Potter Glen, Preliminary Plan No. 120190120

Recommendation – Approval with conditions

Preliminary Plan No. 120190120: Staff recommends approval of the Preliminary Plan subject to the following conditions:

Figure 3 – Preliminary Plan

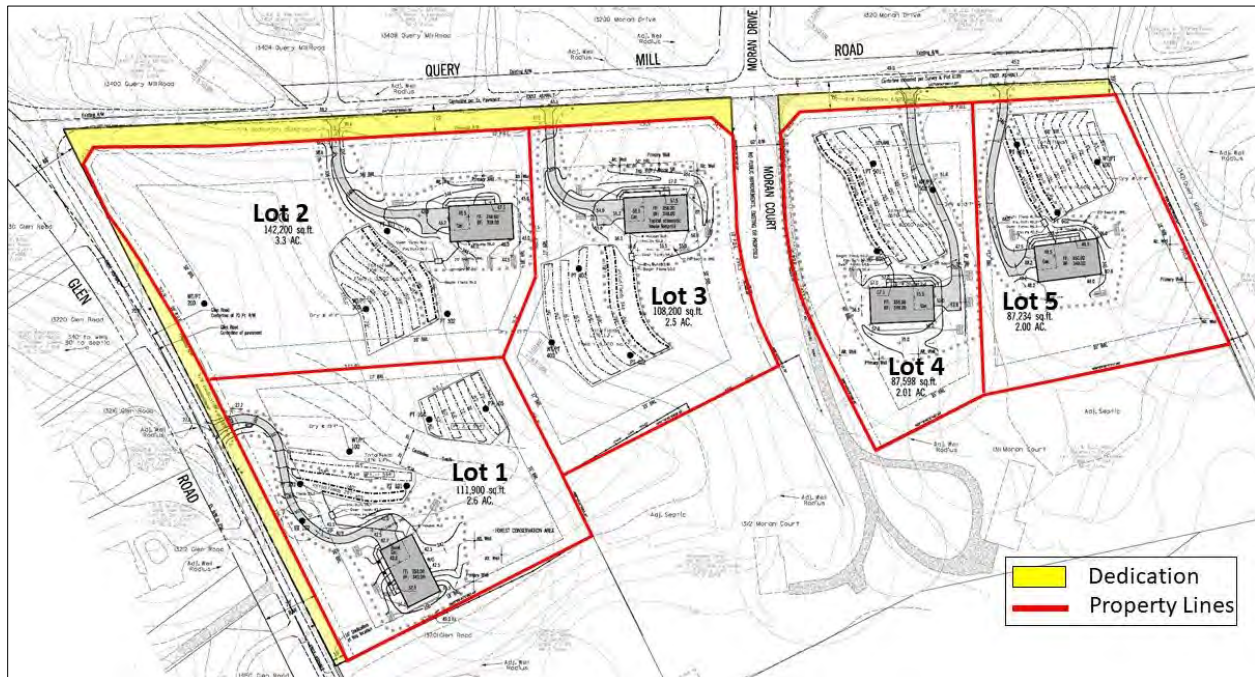
Unfortunately, the proposed development plan that was sent to us does not reflect the Moran Court development accurately as it displaces all utilities, which includes electric, Verizon FIOS underground service and more.

The proposed development shows that the road as it is today will disappear and that there is no plan for replacement or improvement of Moran Court by the developer or the county.

Additionally, the current plan shows that the cul-de-sac shows an opening through our properties to our neighbor, where as we have not authorized building on our private property.

Figure 9 – Moran Court Driveway

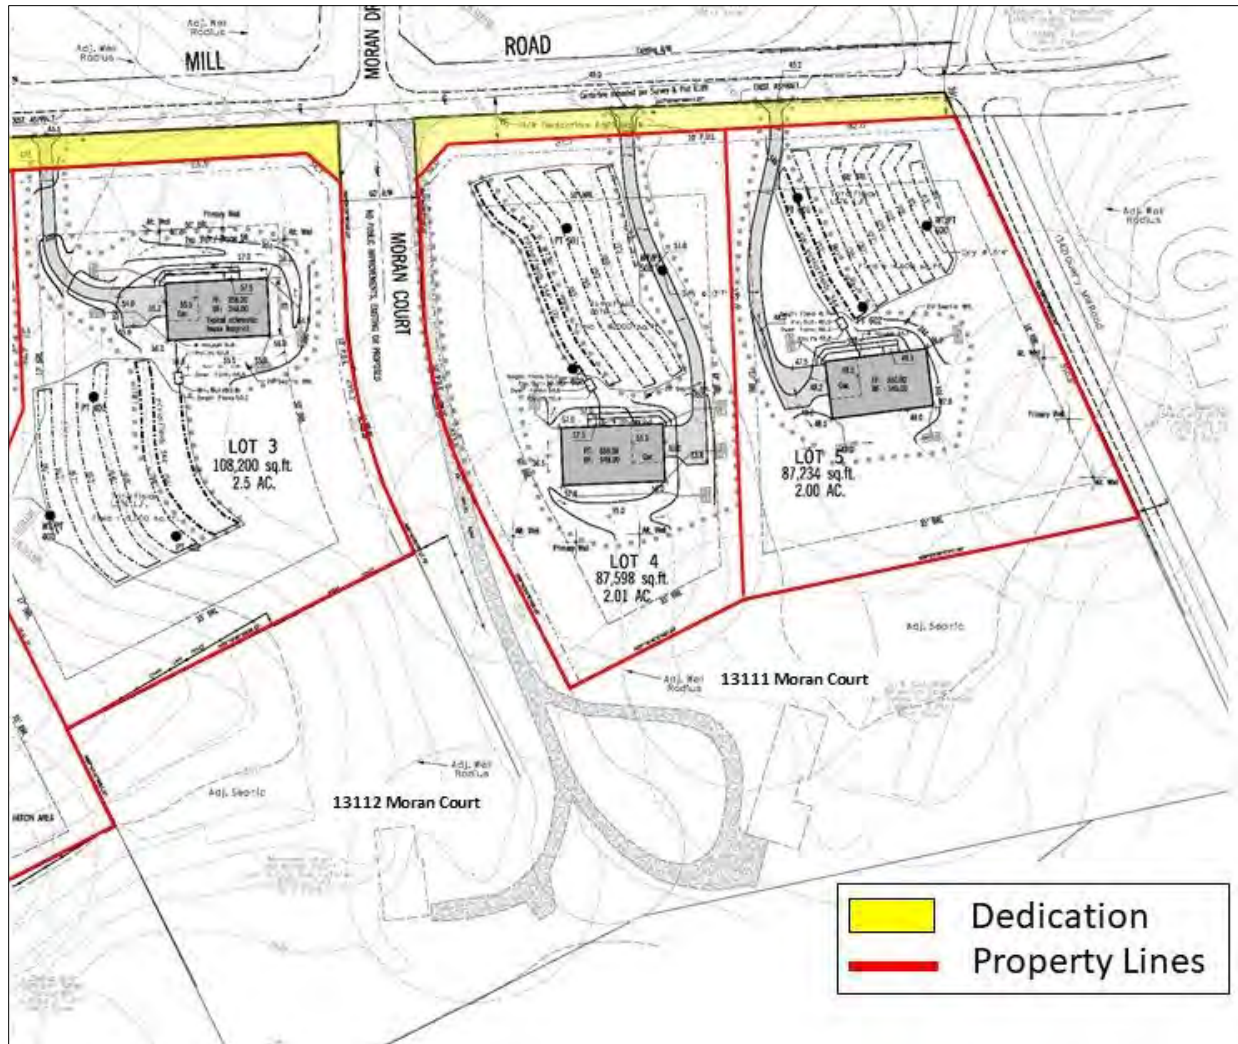
The existing driveway conflict is technically a private matter between property owners, outside the scope of the Preliminary Plan review. However, Staff has coordinated with the MCDOT, MCDPS, RRAC, the Miller's and the Applicant throughout the Preliminary Plan review process in an effort to find a resolution. Throughout the review, Staff received additional correspondence from the Millers (Attachment 11) reiterating their concerns about Moran Court.

Theoretically the existing ROW could accommodate a Tertiary road. However, public streets require a proper turnaround (cul-de-sac) to accommodate maintenance and emergency vehicles. The only logical location for a cul-de-sac is where the platted cul-de-sac was recorded, past the applicant's frontage on Moran Court. Given the size of the proposed subdivision (5 lots), requiring the applicant to provide an off-site improvement for the benefit of the two existing houses does not seem proportionally reasonable. In general, construction of a tertiary public road for the two existing houses on Moran Court is excessive,

Staff supports the proposed private driveway, because it is consistent with what the Rustic Roads Advisory Committee recommended and would continue to provide access to the two existing homes. The Preliminary Plan does not reflect the new driveway because it will be constructed by permit, in the right-of-way in accordance with a private agreement between the property owners. However, the FFCP does account for the removal of the section of driveway that is on the Subject Property.

SUBJECT: Status of Preliminary Plan: Potter Glen
120190120

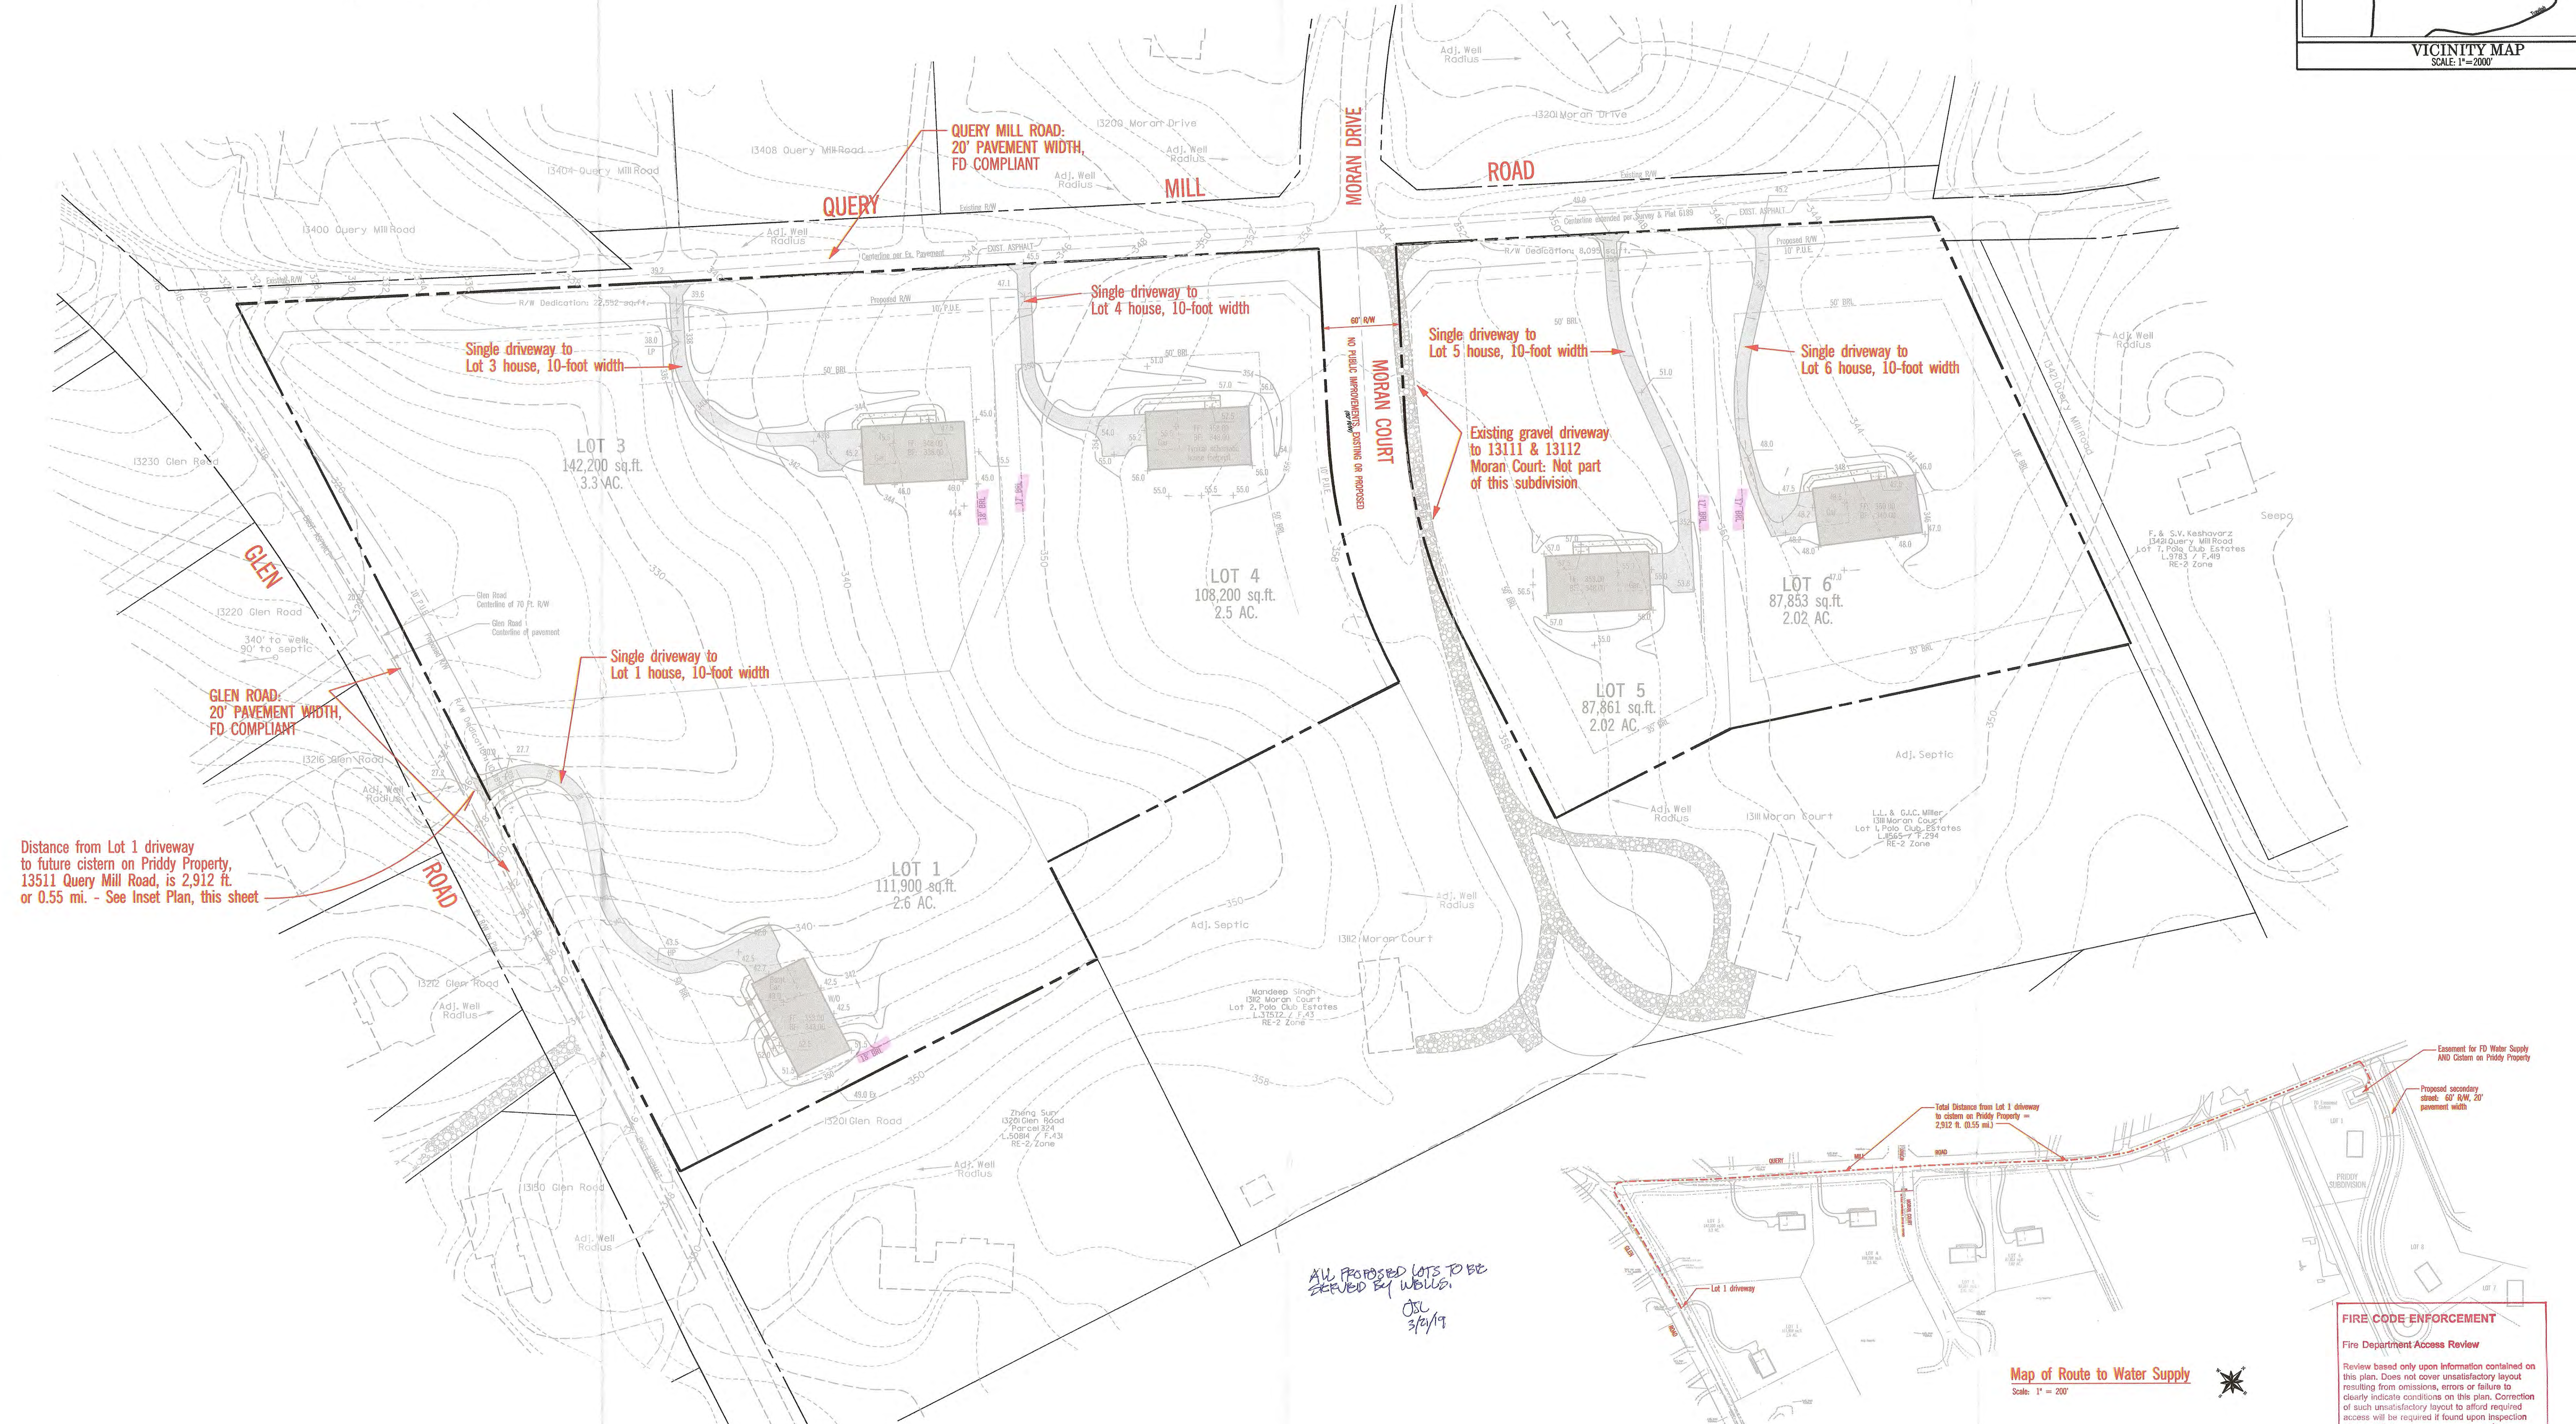
This is to notify you that the Well & Septic Section of MCDPS approved the plan received in this office on June 7th, 2019.

1. The record plat must be at the same scale as the preliminary plan, or submit an enlargement of the plat to match the preliminary plan.
2. The record plat must show the wells and septic reserve areas as they are shown on this plan.
